# Access Compliance Report

## Public Rights-of-Way (Curb Ramps)

Intersection ID: N/A	Main Street: HARPER_CT	Cross Street: N/A	Location: E
ADA ID: 3B6622E29FF0	Ramp Type: Perp	Initial Pass/Fail: Fail	Overall Compliance: No
Codes/Mitigation Info/Possible Solution		Field Measurements/Component Compliance	
Severity Score: 8.75

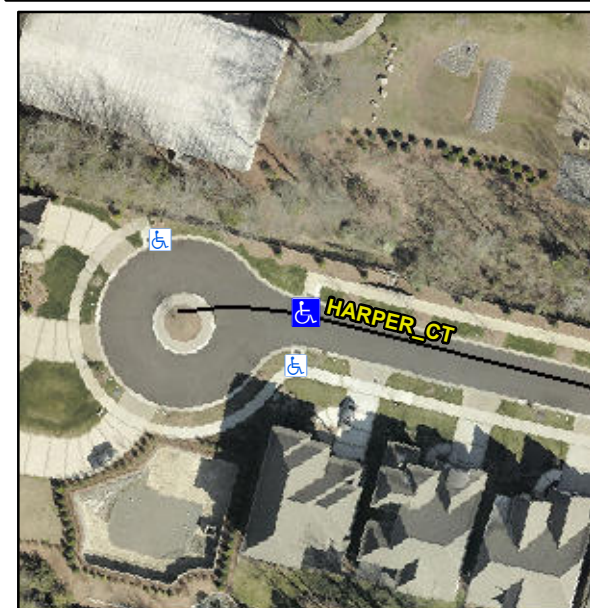
**Not Found, R304.5.1**

Compliance	Description	Data	Compliance	Description	Data
N/A	Ramp Length (in)	95.0	Yes	Ramp Slope (%)	7.5
No	Ramp Width (in)	46.5	Yes	Ramp XSlope (%)	1.3
N/A	Flare Type LT	N/A	N/A	Flare Type RT	N/A
N/A	Flare Slope LT (%)	N/A	N/A	Flare Slope RT (%)	N/A
N/A	Flare Traversable LT?	N/A	N/A	Flare Traversable RT?	N/A
N/A	Landing Length (in)	N/A	N/A	DWS Provided?	N/A
N/A	Landing Width (in)	N/A	N/A	DWS Contrast?	N/A
N/A	Landing Slope (%)	N/A	N/A	DWS Length (in)	N/A
N/A	Landing X Slope (%)	N/A	N/A	DWS Full Width?	N/A
N/A	Landing Curb? (Y/N)	N/A	N/A	DWS Offset (in)	N/A
N/A	Shared Landing?	N/A			
N/A	Gutter Ponding?	N/A	N/A	Gutter Slope (%)	N/A
N/A	Gutter Lip Ht (in)	N/A	N/A	Gutter X Slope (%)	N/A
N/A	Painted X Walk1?	No	N/A	Painted X Walk2?	N/A
	X Walk 1 Direction	To S		X Walk 2 Direction	N/A
N/A	X Walk 1 Width (in)	N/A	N/A	X Walk 2 Width (in)	N/A
	X Walk 1 Slope (%)	1.9		X Walk 2 Slope (%)	N/A
	X Walk 1 X Slope (%)	0.2		X Walk 2 X Slope (%)	N/A

**Remove & Replace Entire Ramp.**
